COUNTY OF RIVERSIDE AIRPORT LAND USE COMMISSION

STAFF REPORT

CASE NUMBER: ZAP1051TH20 - Thermal House, LLC (Representative:

PROJECT DESCRIPTION: The applicant proposes to construct a 624 square foot rooftop solar panel system on a proposed single family residence located at 86814 Newton Way within the Thermal Motorclub.

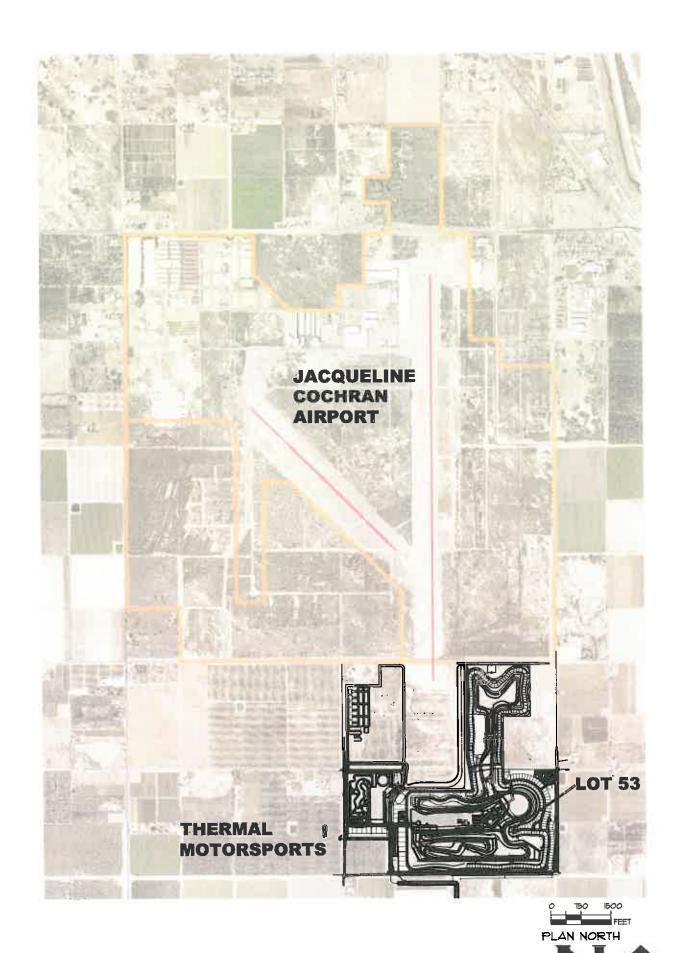
The analysis concluded that some potential glare would occur within the 2 mile approach to runway 30. Evaluation of the approach indicate that the panels would result in low potential for temporary after-image ("green" level glare), totaling annually 761 minutes of "green" level glare, lasting up to 10 minutes a day between March and May, and August and October from 5:30 p.m. to 6:30 p.m. (pacific daylight time). Overall, less than one percent of annual daylight time would be affected.

0 minutes of yellow glare 761 minutes of green glare

- 4. All solar arrays installed on the project site shall consist of smooth glass with anti-reflective coating, a fixed tilt of 8.0 degrees and orientation of 165 degrees. Solar panels shall be limited to a total of 624 square feet, and the locations and coordinates shall be as specified in the glare study. Any deviation from these specifications (other than reduction in square footage of panels), including change in tilt or orientation, shall require a new solar glare analysis to ensure that the amended project does not result in any glare impacting the air traffic control tower or creation of any "yellow" or "red" level glare in the flight paths, and shall require review by the Airport Land Use Commission.
